RE: BCHS PSC - BG 25-145 - Change Order 13 - Concrete Control Joint Installation

Change Order

CHANGE ORDER INFORMATION:
 Change Order Number: 013

Change Order Request 14 - PCO #31 - BCHS Control Joints 2nd Level

BCHS Control Joints 2nd Level

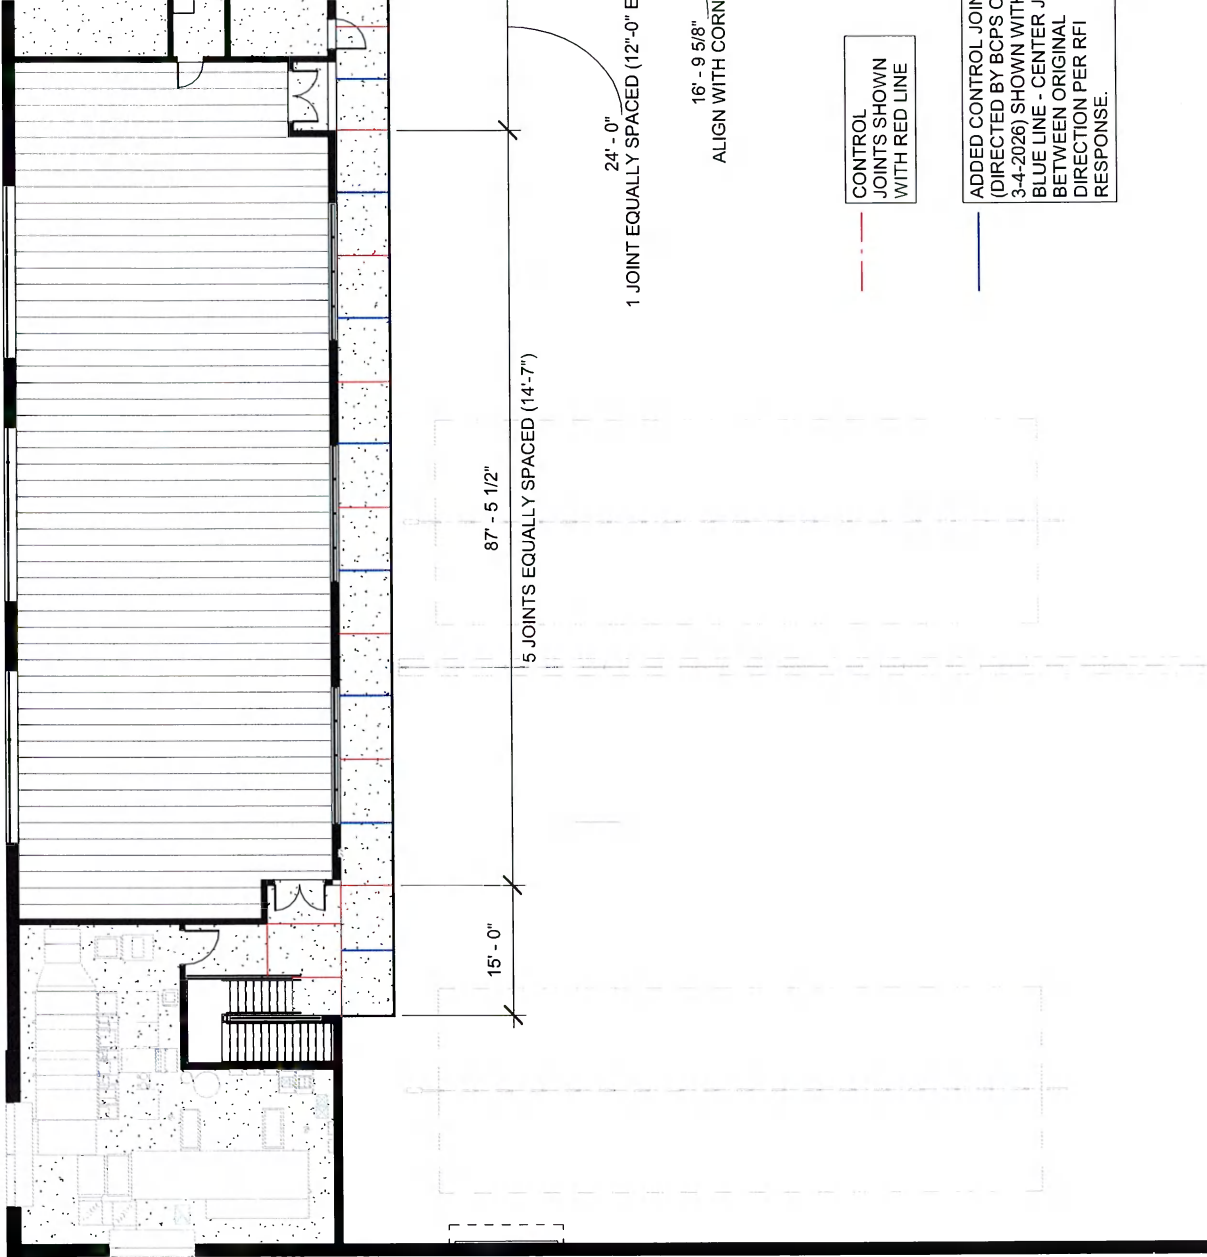
It is recommended that additional control joints be added at the elevated walkway concrete slab to mitigate superficial cracking. Joints were added by the architect, and then additional joints were requested by Facilities. Prior to the addition of joints as directed by Facilities, the contractor moved forward with separate joint pores for the architect directed control joints. After joints were placed, it was confirmed joints can be saw cut and achieve similar results. This Change Order covers work for both the architect directed control joints and additional joints as directed by Facilities.

CONTROL JOINTS SHOWN WITH RED LINE

ADDED CONTROL JOINT (DIRECTED BY BCPS C 3-4-2026) SHOWN WITH BLUE LINE - CENTER J BETWEEN ORIGINAL DIRECTION PER RFI RESPONSE.

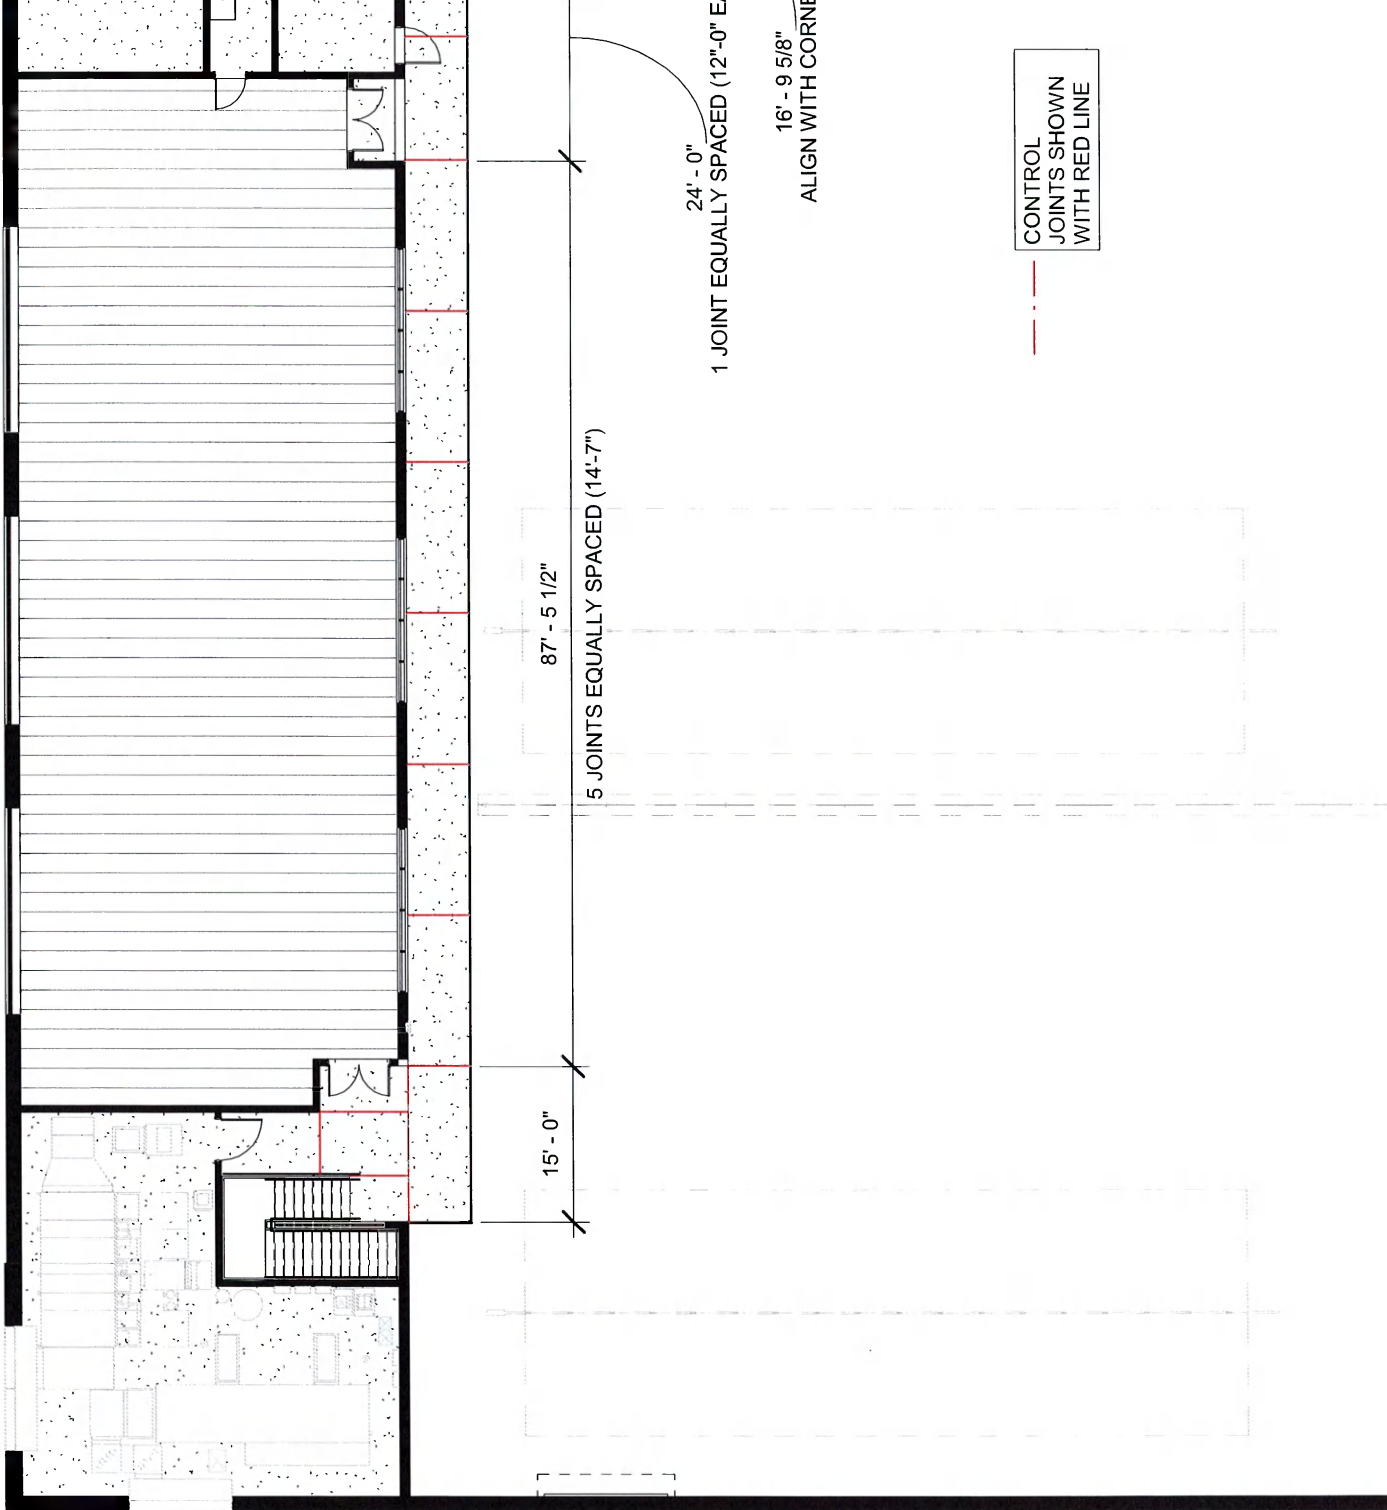
The joints on the second-floor topping slabs are delineated "CJ". There are no specific joint details provided for the topping slab. Detail L/S3.1 depicts (2) joint options for construction joints and (2) joint options for contraction joints. Calhoun Concrete suggests using the option for stay in

place pour stop, (labeled number 4 on attached sheet). Please advise if this is acceptable.

Response: Detail L/S3.1 does not apply to topping slabs, only slabs on grade.

Sawn contraction joints are not permitted, and the following shall be implemented during construction:

- Construction joints must be formed and welded wire fabric must be continuous through the joint
- Sections between construction joints should be poured alternately, with at least a week gap between pours
 - For example, every other section can be done in pour 1 and the remaining will be completed in pour 2 (this is an example, exact construction technique is a contractor means and methods item)

SKA, please advise if the same joint pattern used at North Bullitt (attached for reference) is your preferred layout, or if you would like to make revisions.
